ADDENDUM

ADDENDUM NO: 1

PROJECT: East Elementary Roofing Replacement

PROJECT NO: 2024042

1 ROOF DEMOLITION PLAN
AD100 SCALE: 1/16" = 1'-0" NORTH

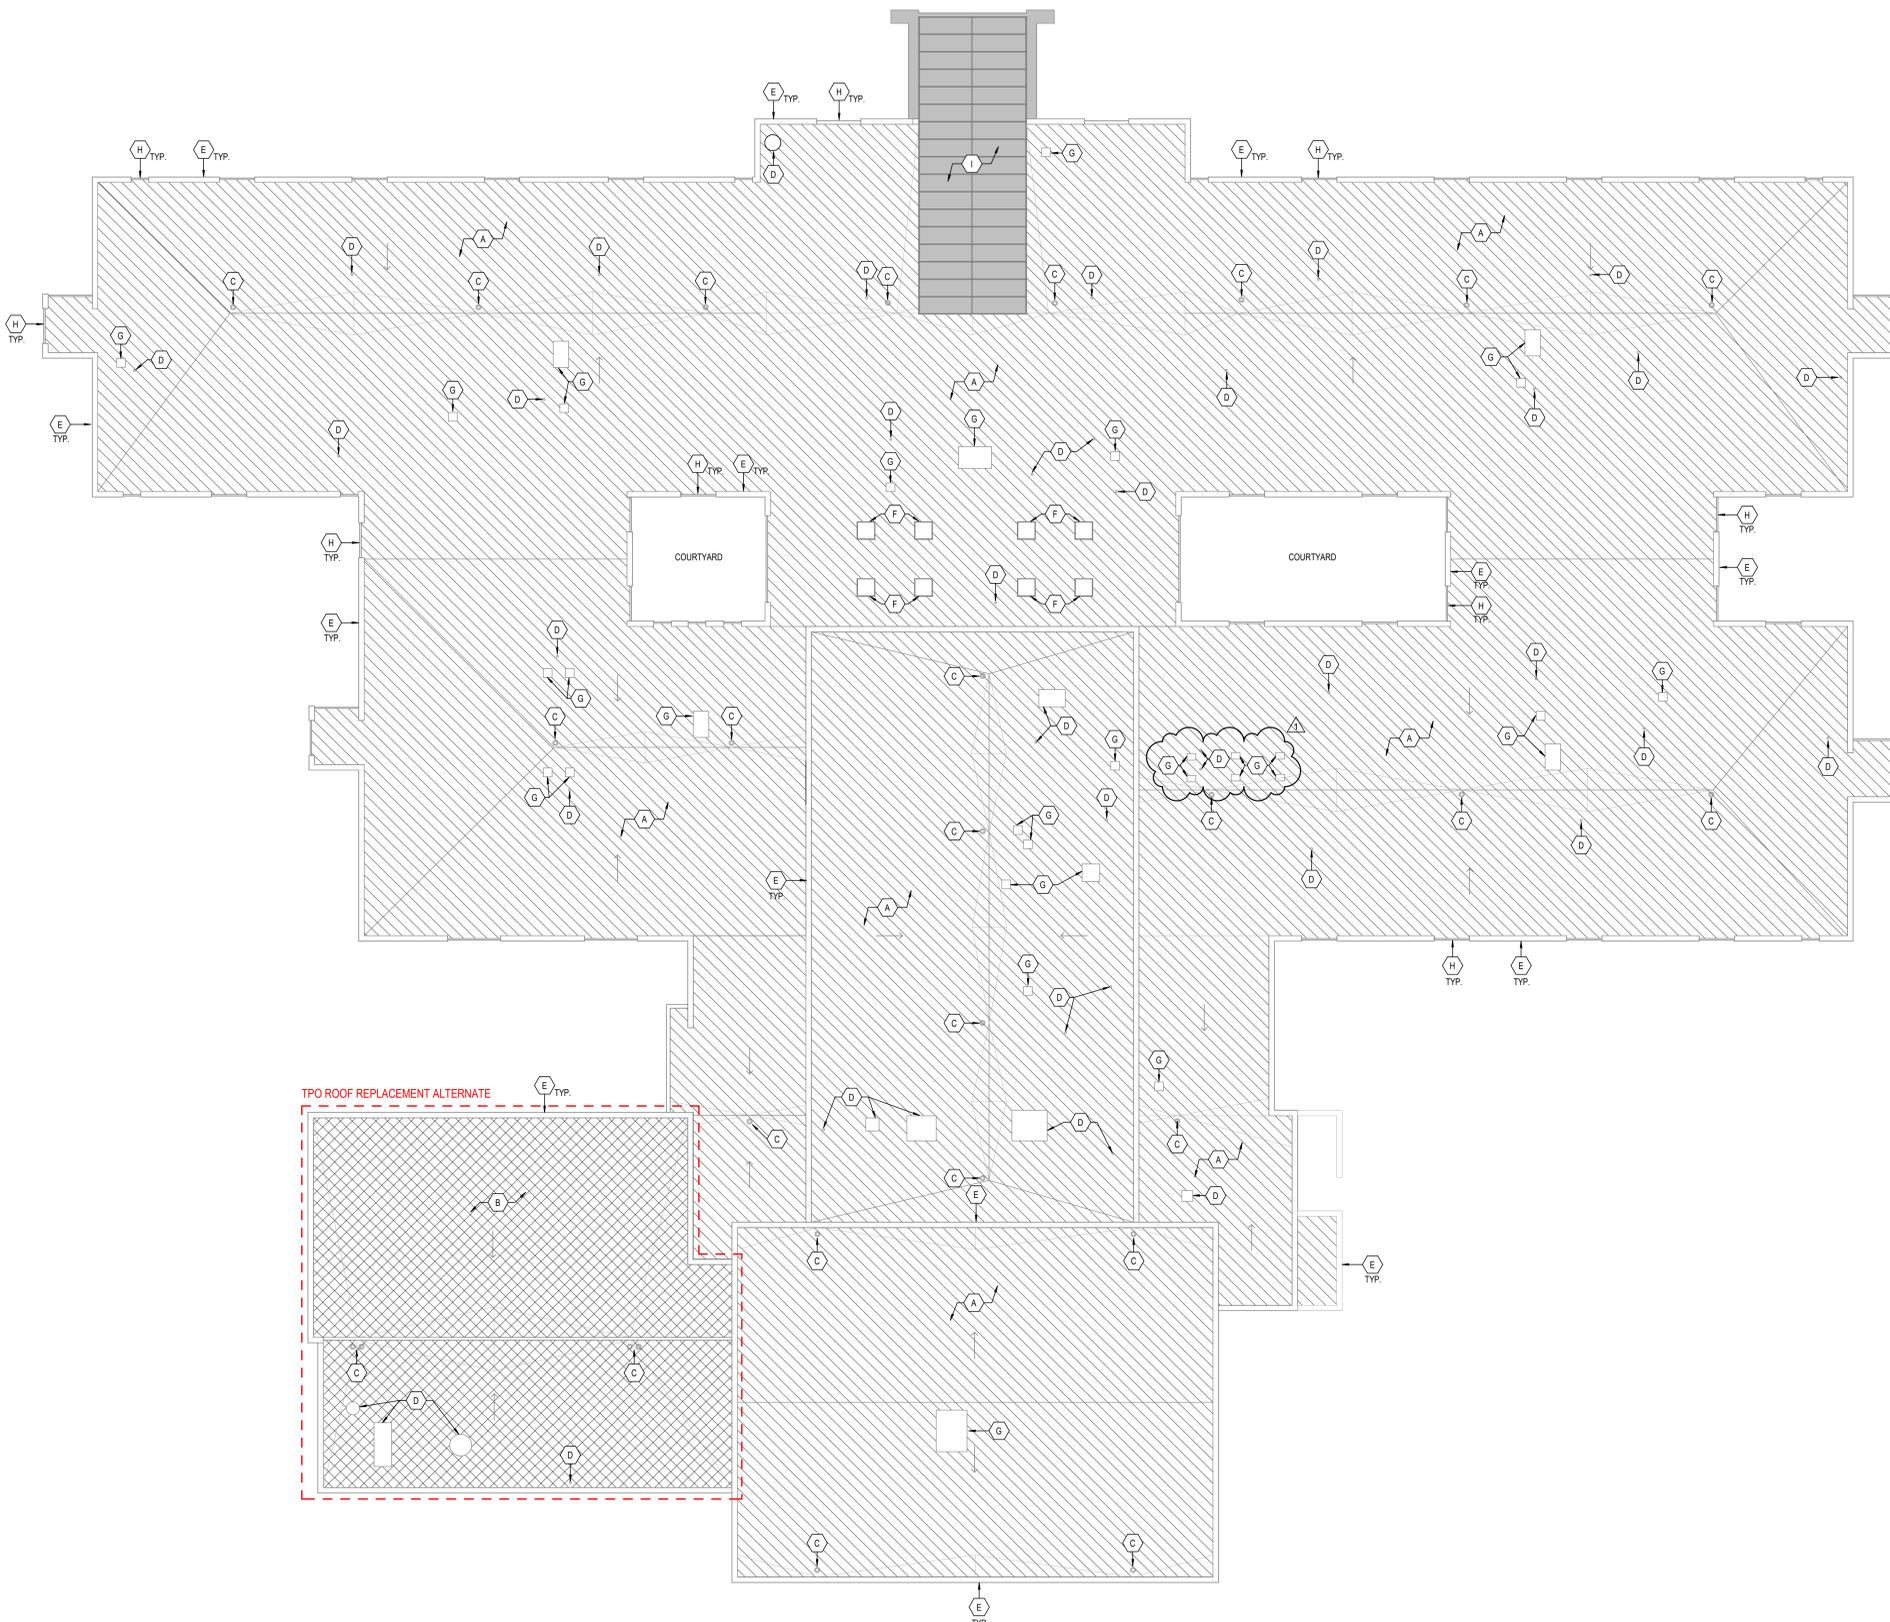
3.01 AD100 – ROOF DEMOLITION PLAN

- A. Add additional roof curbs/ equipment and notes as shown on the attached sheet.
- B. Revise roof demolition note "E" to include alternate information.

5.01 A question was raised at the pre-bid meeting about removing existing structure for previous roof top mechanical equipment.

- A. Response: The structure should remain for future flexibility. The drawings have been updated to reflect this area for clarity.

- C. REMOVE ROOF DRAIN AND SAVE FOR REINSTALLATION AT SAME LOCATION.
- D. MECHANICAL OR PLUMBING EQUIPMENT TO REMAIN.
- E. SALVAGE METAL COPING FOR REINSTALLATION. (ALTERNATE - REMOVE METAL COPING COMPLETE.)

1 COMPOSITE ROOF PLAN
 A100 SCALE: 1/16" = 1'-0"
 NORTH

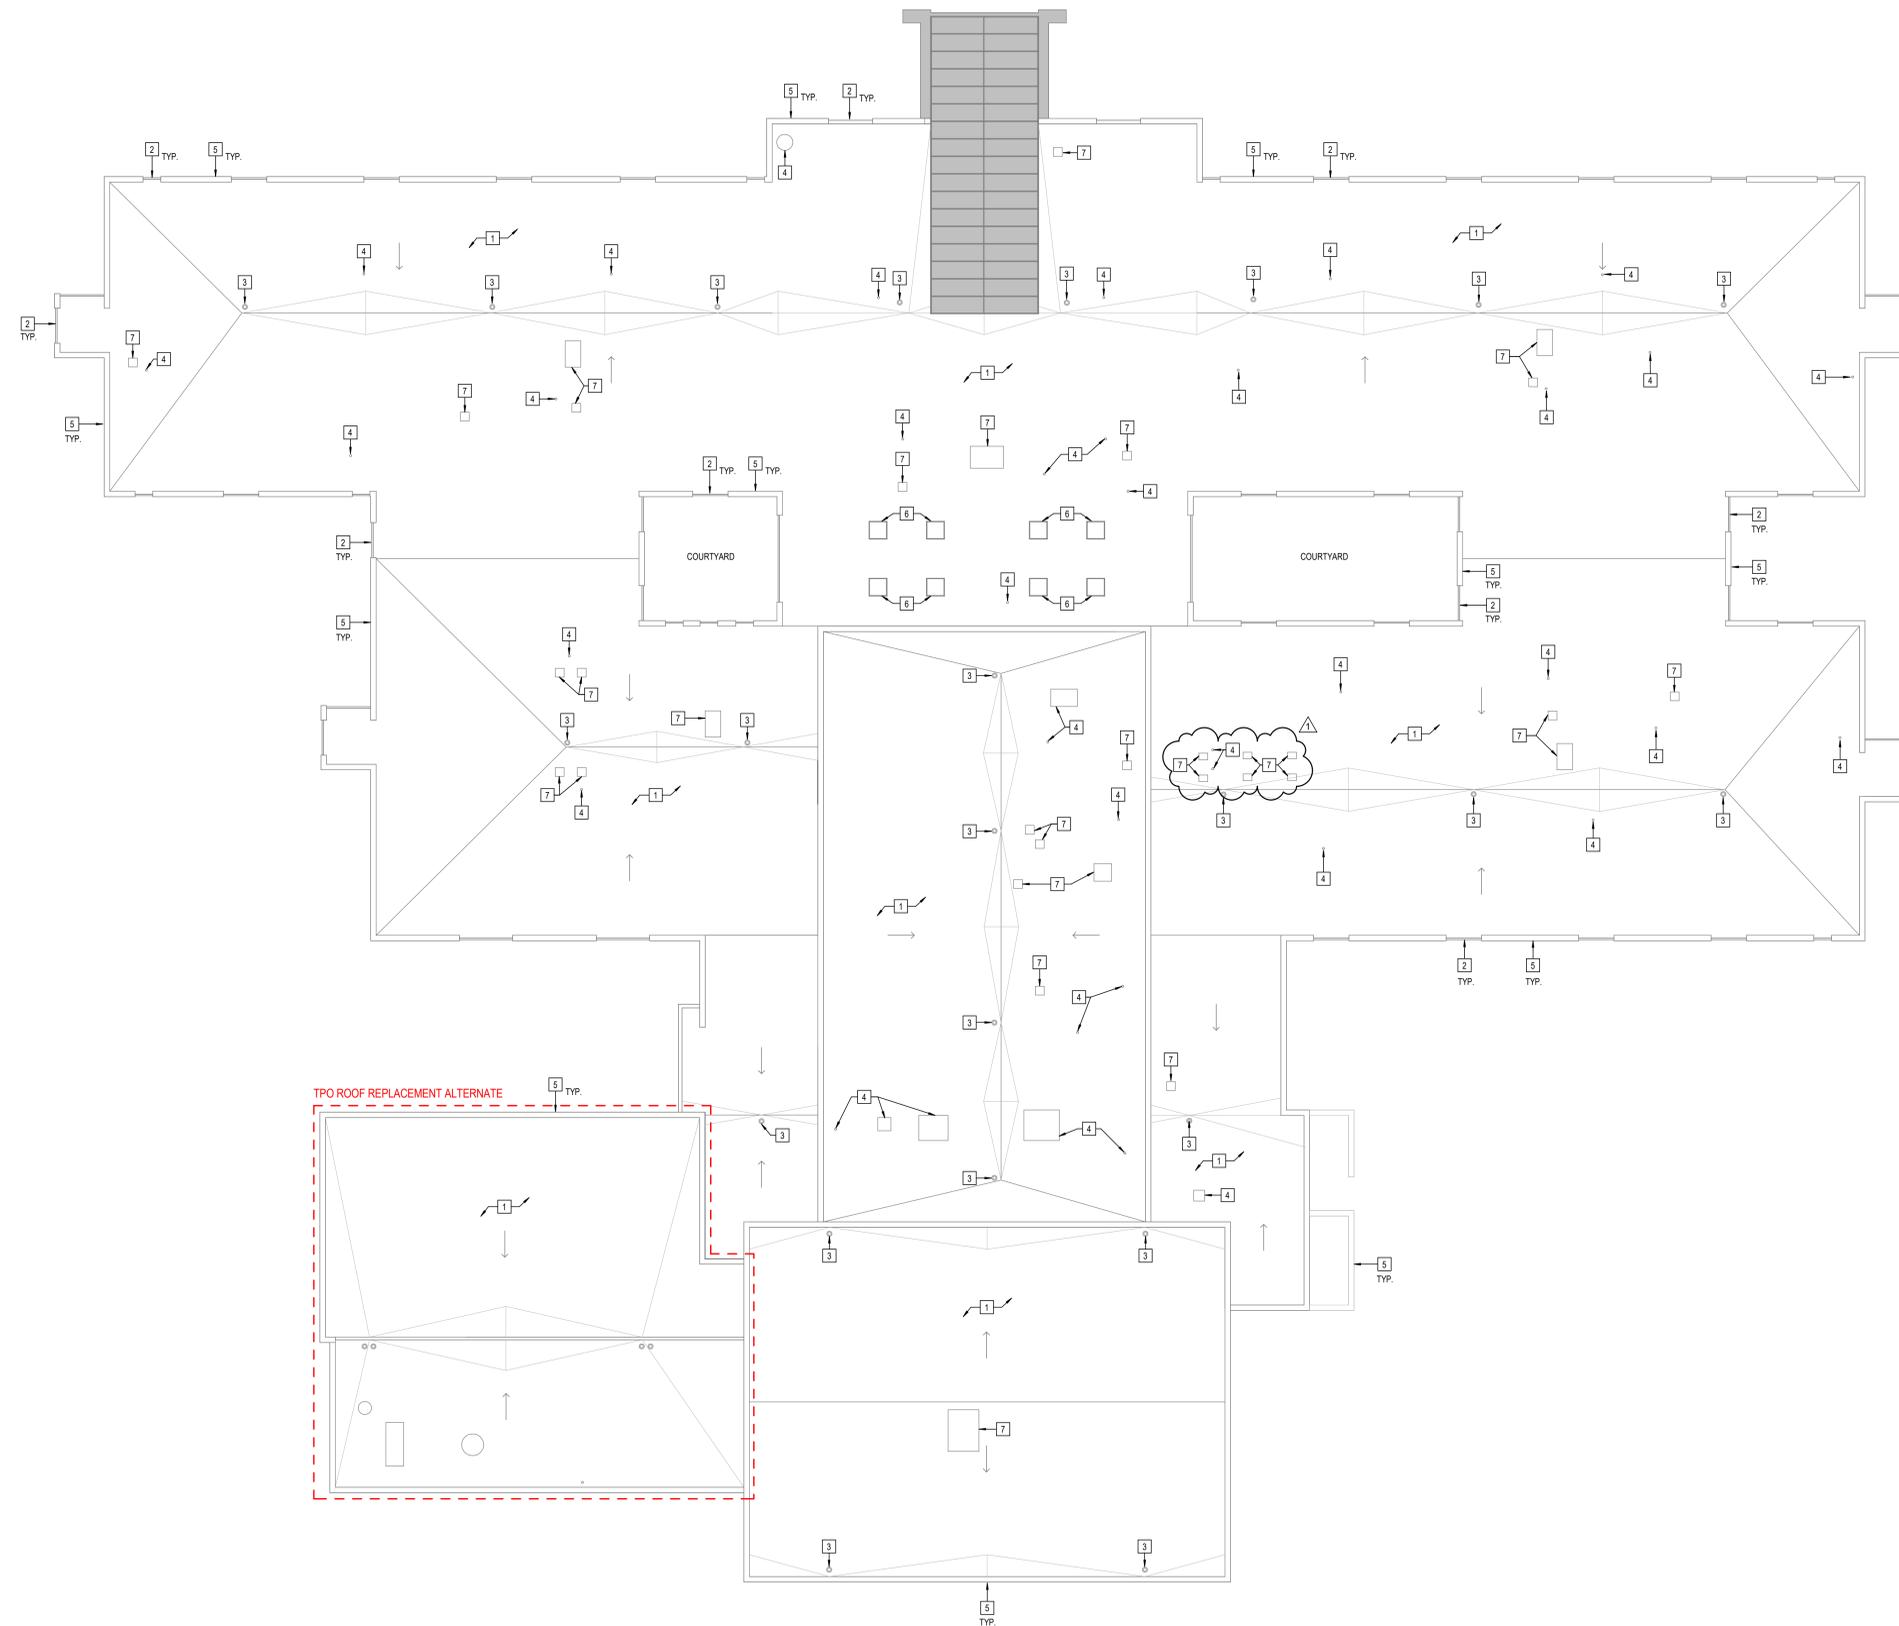
3.02 A100 – COMPOSITE ROOF PLAN

- A. Add additional roof curbs/ equipment and notes as shown on the attached sheet.
- B. Revise roof plan note “5” to include alternate information.
